09-RENEW EO-1

Re: Detailed Comments on Draft Revised DRECP Biological Goals and Objectives

Date:	March 21, 2012
To:	Dave Harlow, Director of the DRECP Scott Flint, DRECP Program Manager, California Energy Commission DRECP Stakeholder Committee
Cc:	Renewable Energy Action Team (REAT)
From:	ICF International, Dudek
Subject:	DRAFT Revised DRECP Biological Goals and Objectives

Figure 1. DRECP Conservation Strategy Conceptual Model

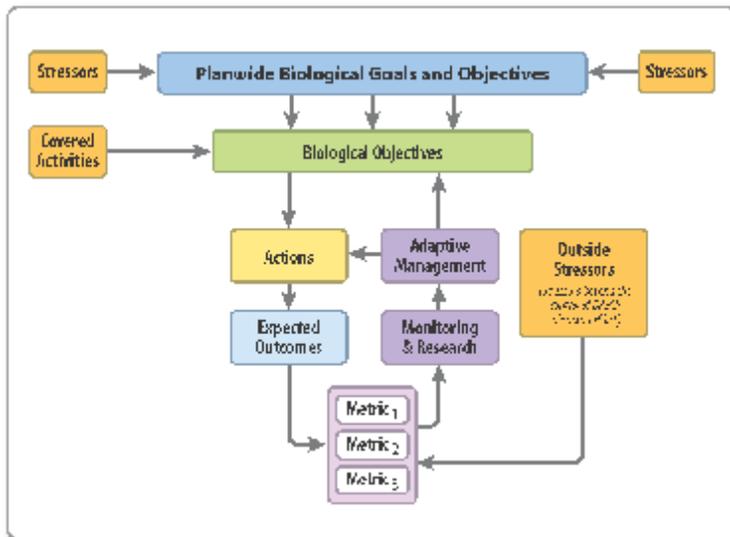
Comment [SD2]: Defenders: Stressors also inform the biological objectives. There should be an arrow from stressors to biological objectives. The scope of the biological objectives needs to be clarified - do objectives only relate to stressors caused by renewable energy development?

Figure 2. Integration of DRECP Biological Goals with the Plan-wide Reserve Design Process

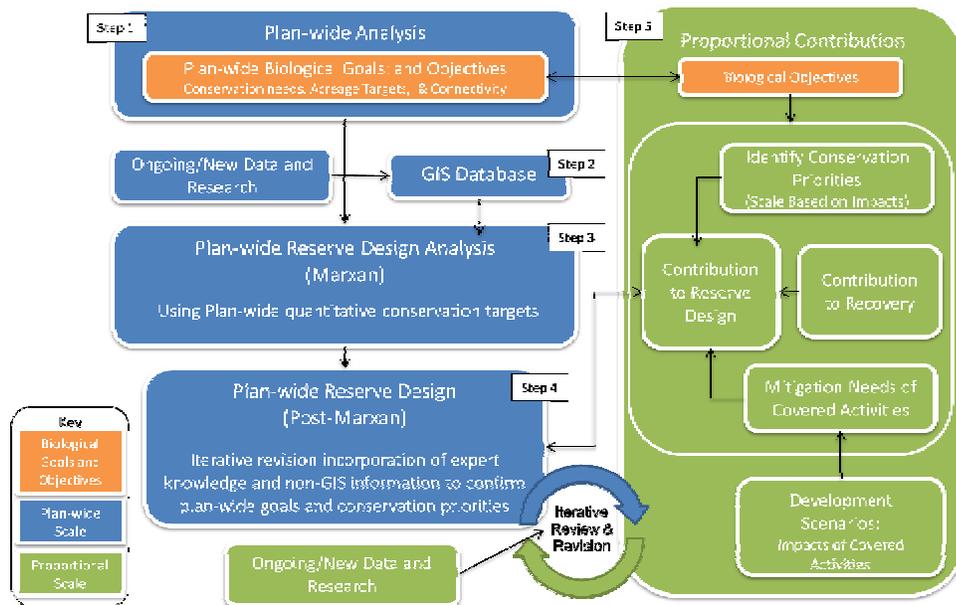
Comment [SD13]: Defenders: There is no link in this diagram between the biological objectives and the Marxan analysis. It seems that you would want the biological objectives to inform the conservation targets for the Marxan. Please clarify.

Comment [SD14]: Defenders: Isn't this still part of the post-Marxan process?
